DESCRIPTION OF CIRCUITRY

RULE PART NUMBER: 2.1033 (c)(10)

1.Changes undergone by T857

1.1. Class II type Permissive changes - T857 UHF Exciter

3. Schematics of the changes

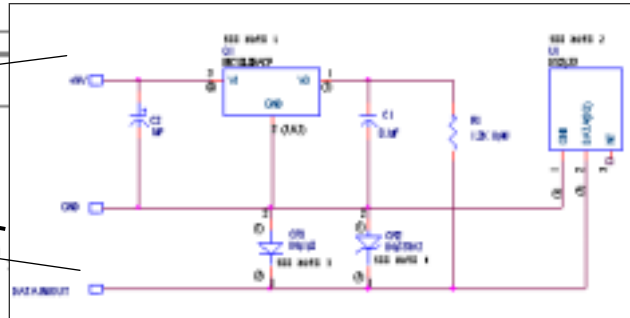
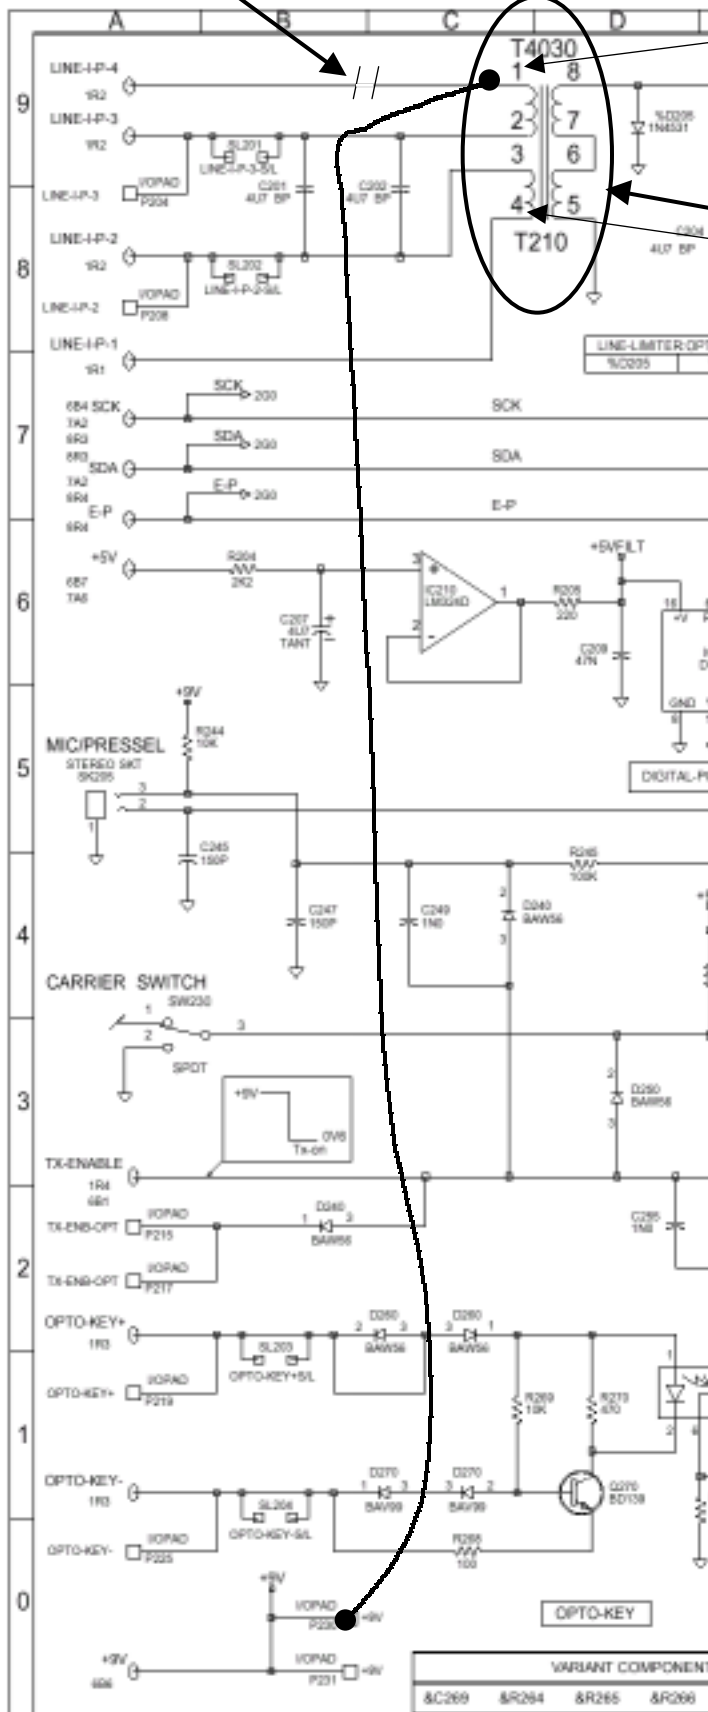
The resistor R 290 which connects the output of the audio low-pass filter (IC260) to the buffer that fed the splitter between the input of the VCO buffer (R293, IC260) and the Modulator reference (RV220, IC210) has been removed. Its output pad has been connected to the TXA signal through a soldered wire.

The TxA signal has been brought in using CTCSS input (pin 8) whose line has been disconnected by removing C265 and R259 from the original PCB and extended via a soldered wire up to the pad mentioned before. All the steps are detailed appropriately in the production procedure nr. 164-20006-031 which is provided as Annex C.

Cut

We removed XMMF T4030
Line match potcore (T4030) to
put this EEPROM module
